**Subject:** Eagle Rising SF2225 Plat Filing No. 1 - Two Unresolve comments

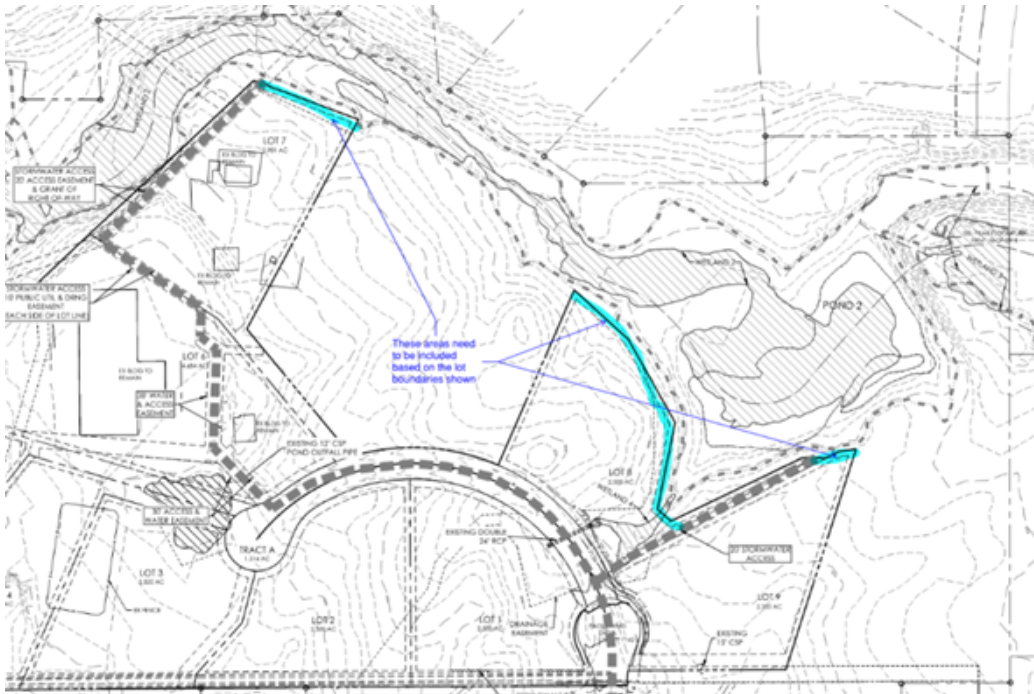
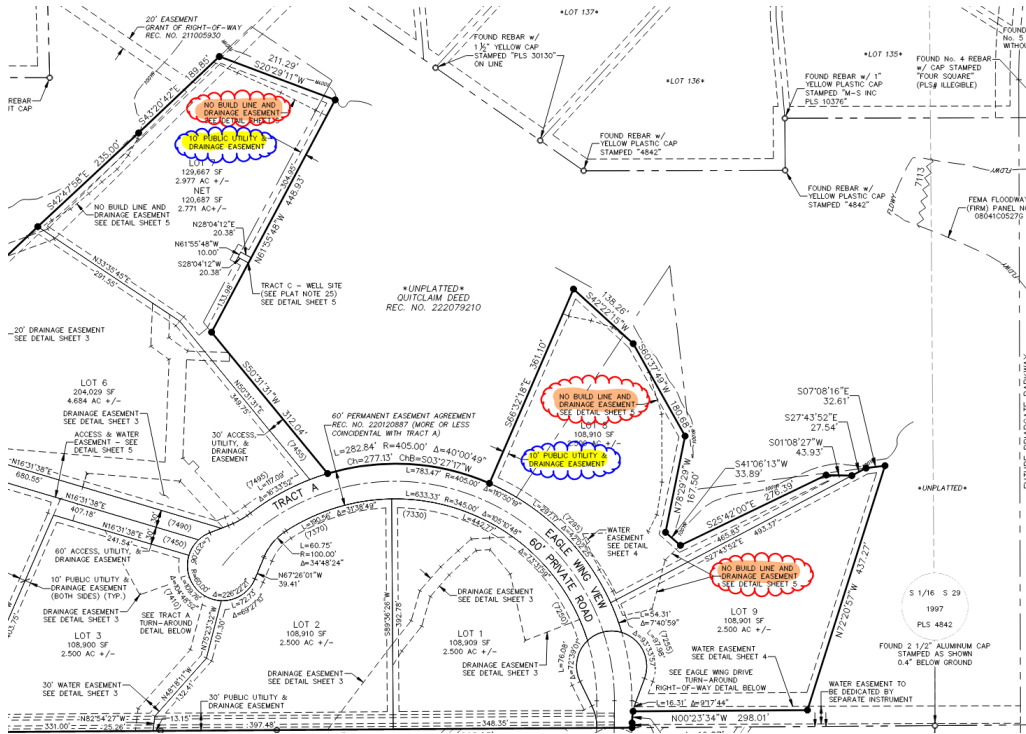
- However, as noted the EPC review engineers are requesting that the Lot 7, 8, and 9 Lot property lines be adjusted to be a minimum of 15' from the 100-year water surface line. Considering the 10' easement and the Access to the Creek Exhibit there is no rational engineering basis for this additional 15' to further reduce the size of the Lots. Also, there is no justification for adding access along the back side of the Lots for access to the Creek.

- There is a 10' public utility and drainage easement on all sides of the inside perimeter of each Lot. See the yellow highlighted notes on the screenshot extract of the Filing No. 1 Plat below. Access to the Creek for maintenance is shown on PDF page 209 of the Final Drainage Report, (screenshot below), is consistent with the approved Channel Deviation and meets the criteria and intent of ECM 3.3.3.K2.

- Furthermore, the No Build and Drainage Easement Lines shown on the Plat, (highlighted in red below), are 2' above the 100-year water surface elevation even further away from the 100-year line out of an abundance of caution vs. only 1' as require for a FEMA Floodplain. NOTE: The 100-year water surface is not classified as a FEMA Floodplain.
